Planning & Zoning Board

**MINUTES REGULAR MEETING
REYNOLDSBURG PLANNING & ZONING BOARD
February 22, 2024**

RE: Aurtec Designs LLC/Victor Nduaguba & Ugo Nwoke; 441 Waggoner Road: Major Site Plan Application

Below is the staff review of the above referenced Major Site Plan Application.

WAGGONER ROAD
PROPOSED SITE LIGHTING PLAN

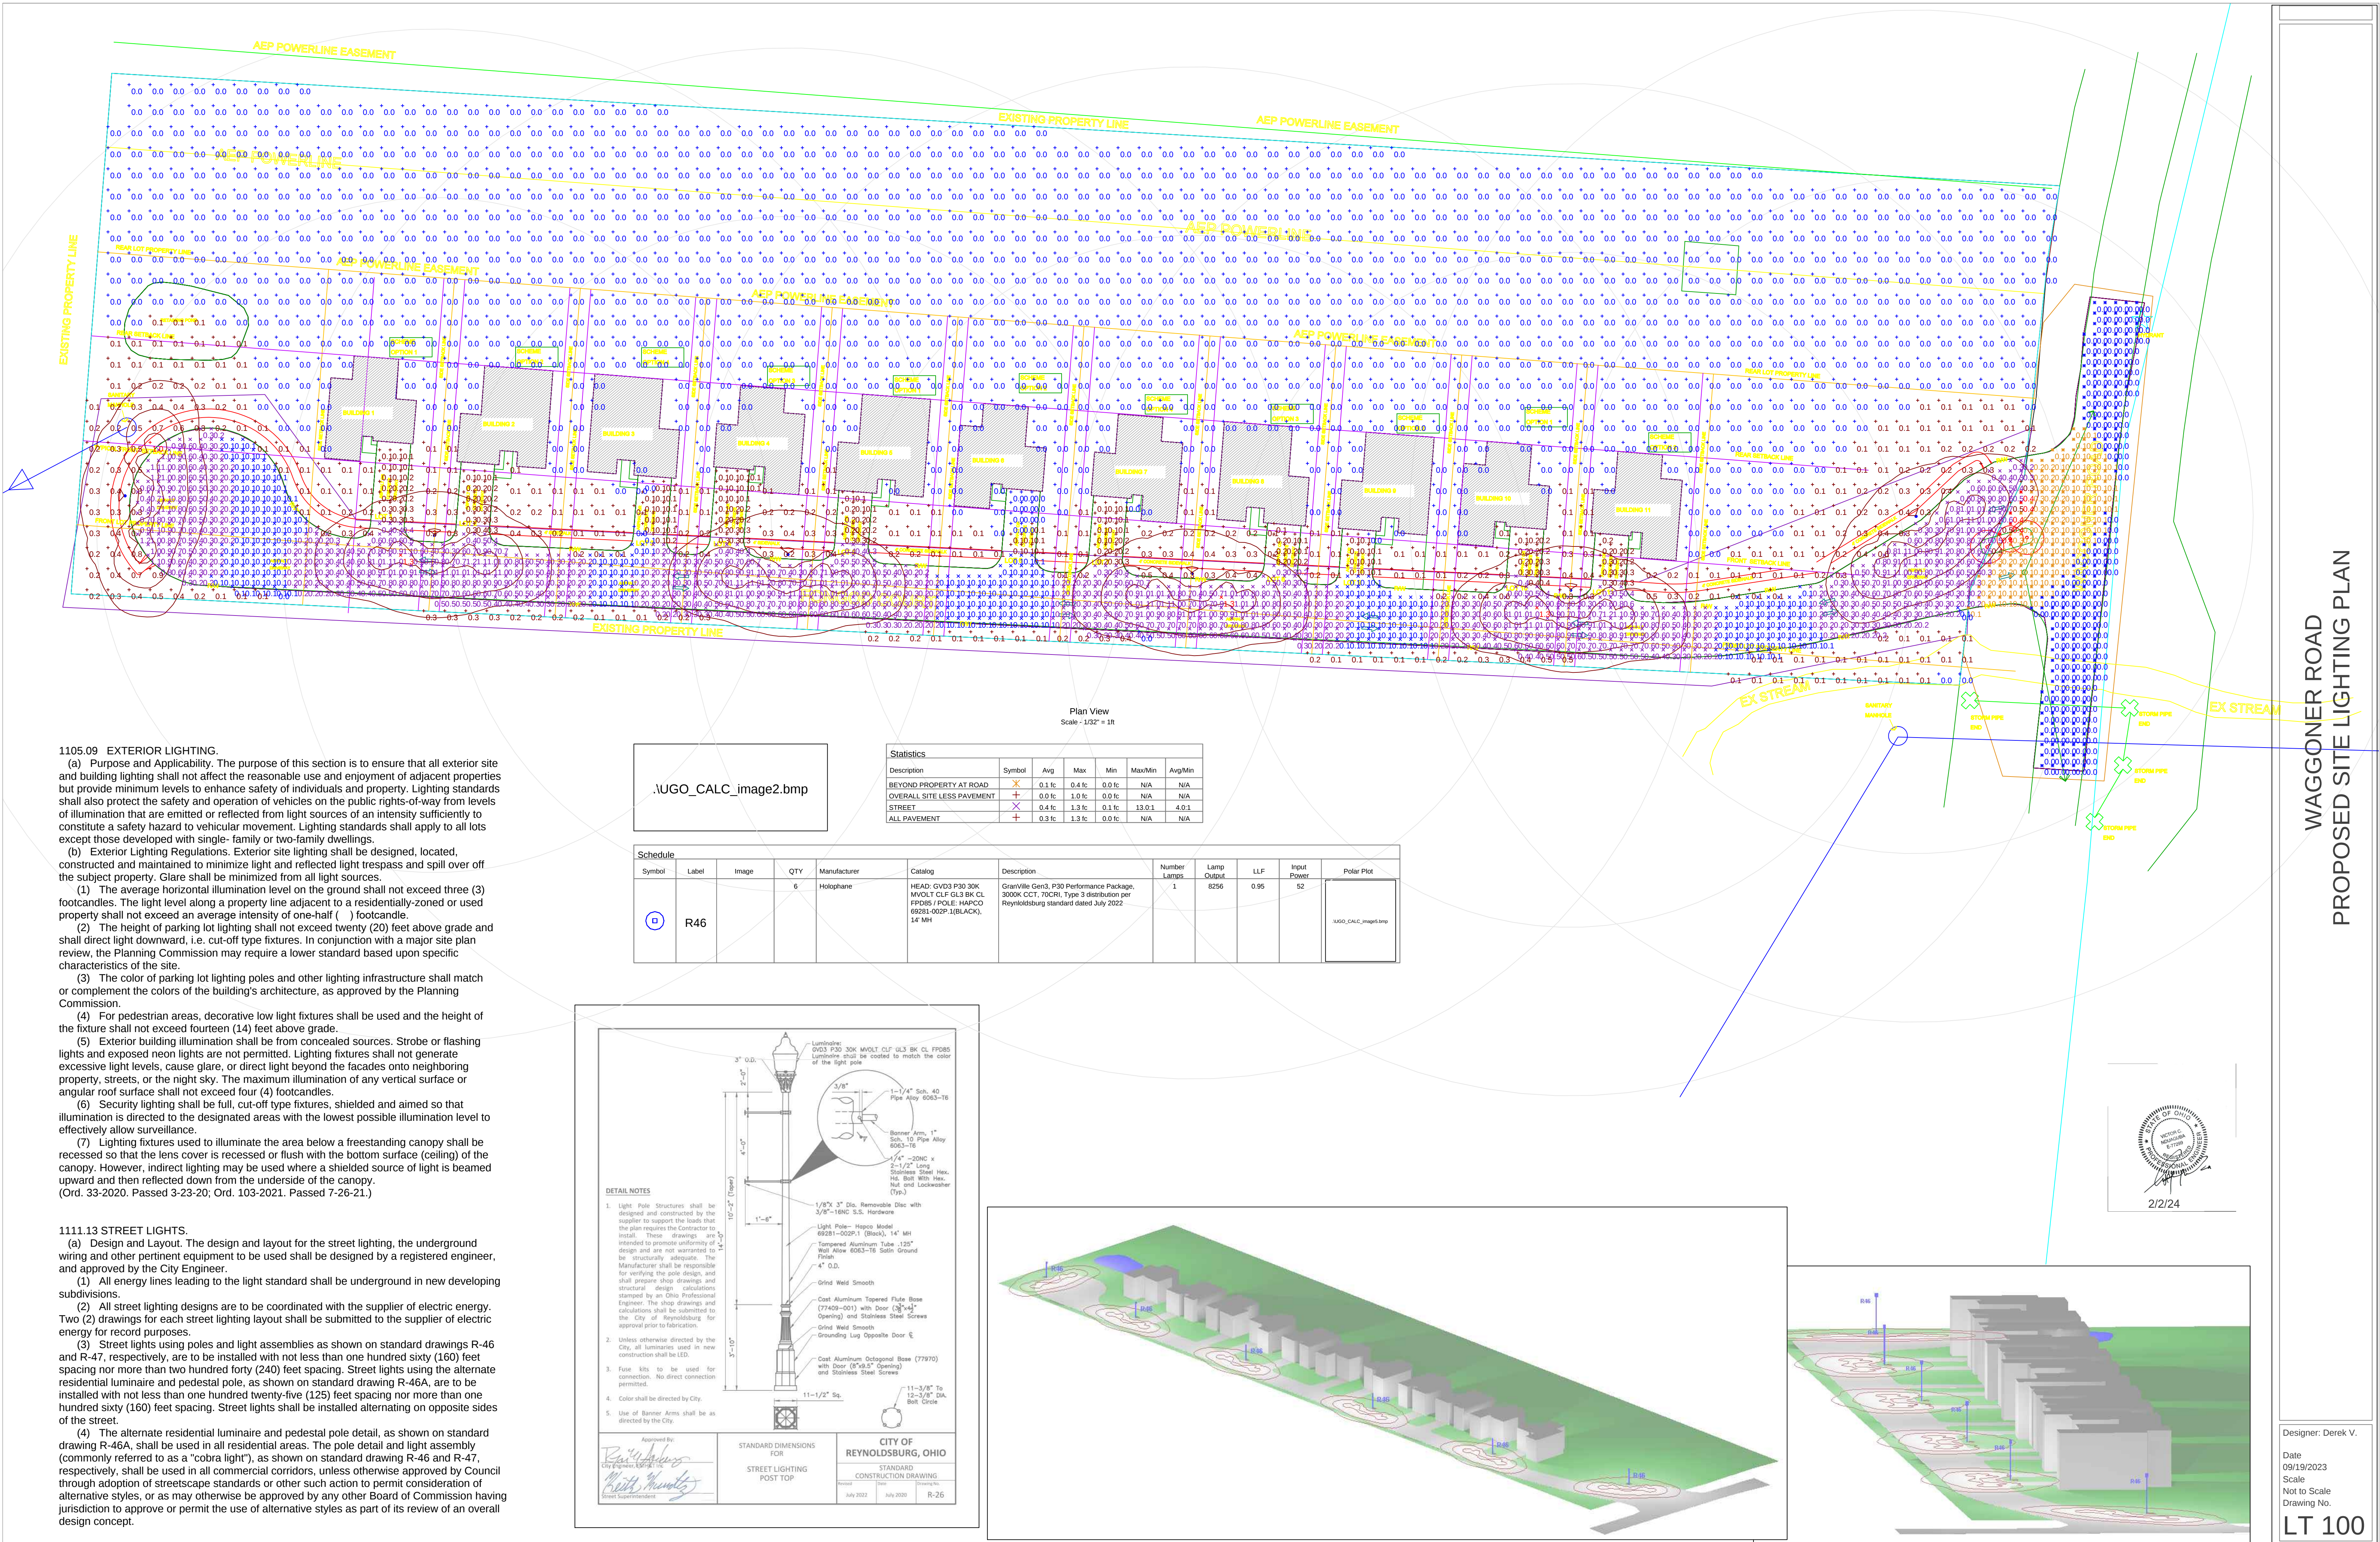
- i. Color of all poles not indicated on lighting plan. Please provide required color that is used for all residential developments within the

- i. Streetlights are proposed along the private street. The photometric plan indicates that average foot-candles for the various areas of the site will be 0.4-foot candles or less. The point calculations indicated along the south property line shared with an adjacent residential use appear to comply with the 0.5 FC maximum.
- ii. The proposed light fixture will be the standard city light fixture, with a pole height of 14 feet.

PROJECT NAME	WAGGONER RD	PROJ #	1495	DRAWN BY	AC
TITLE	LANDSCAPE PLAN	DRAWING #	L001	DATE	9-21-2023

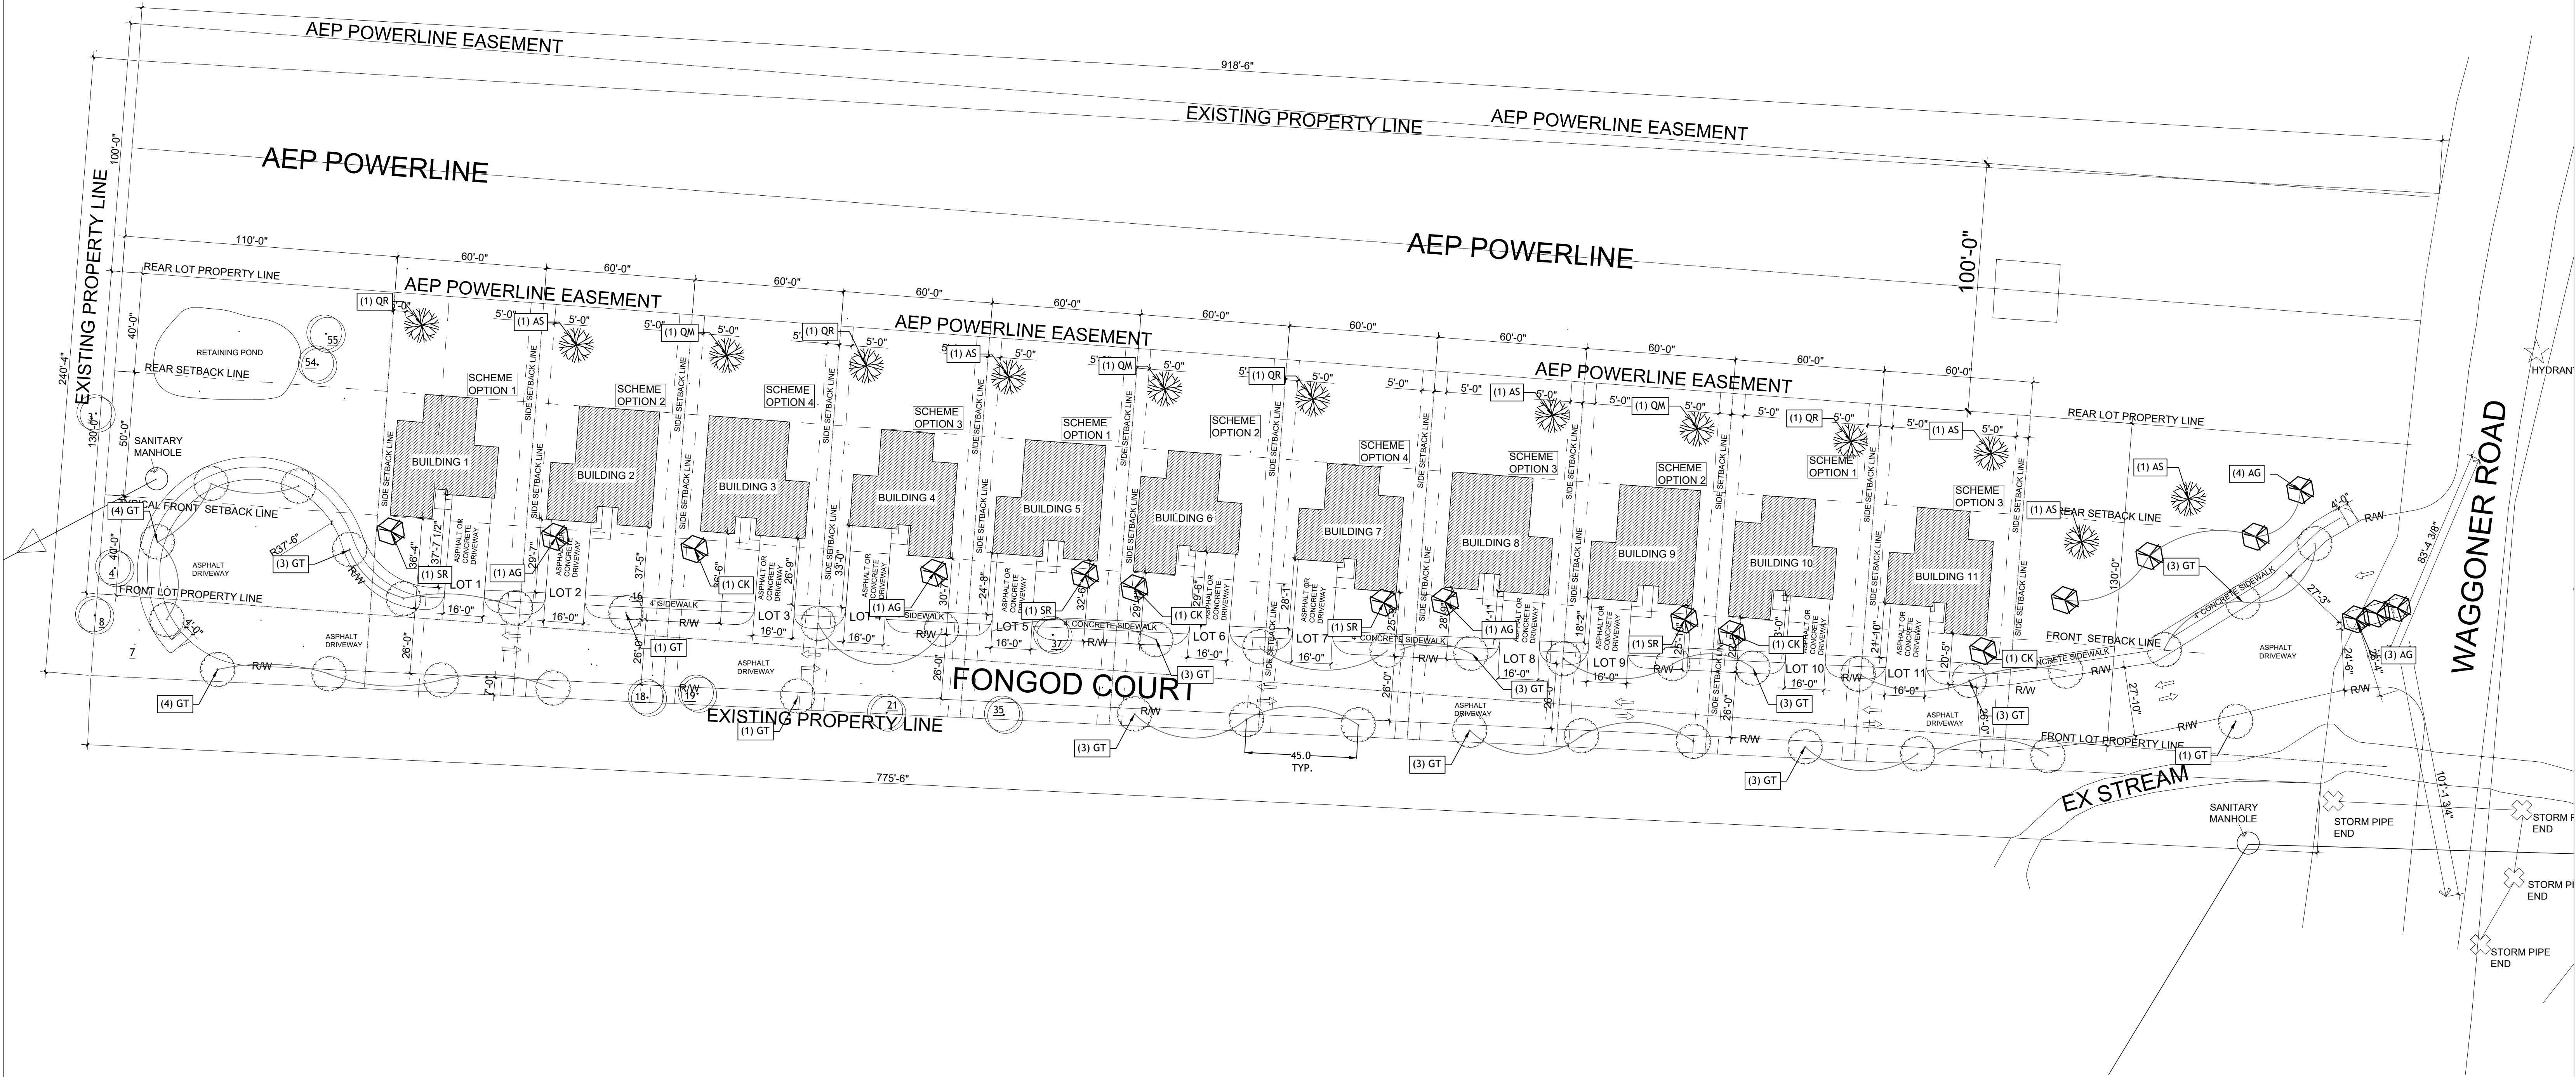
- i. The Utility location is not indicated on the landscape plan.
- d. *All existing conditions, including but not limited to ditches, culverts, waterways, utilities, sidewalks, power poles, easements, building footprint and finish grade, finish grade of adjacent buildings, wetlands, and woodlands, etc.*

n. **Interior Lot Landscaping:** *All residences and residential land uses, per dwelling unit, there must be planted one- half inch (1/2") in trunk diameter for everyone 3,000 square feet of lot size or fraction thereof, with a minimum of two inches (2") of total trunk diameter.*

i. Each lot is required 2.34" of trunk diameter. The plan provides two (2) 1.75" caliper trees per lot (3.5" trunk diameter per lot). Please know that each tree will need to meet the minimum diameter of 2", which it currently does not at 1.75".

- vii. The location and type of all new landscape material and plantings, including street trees. Utilities shall be shown on all landscape plans. Utility location not indicated on the landscape plan. **For ease of reading the plans, it was advised to separate the plan elements to their main subject title. We can overlay these elements during post zoning site engineering and building permit submissions.**
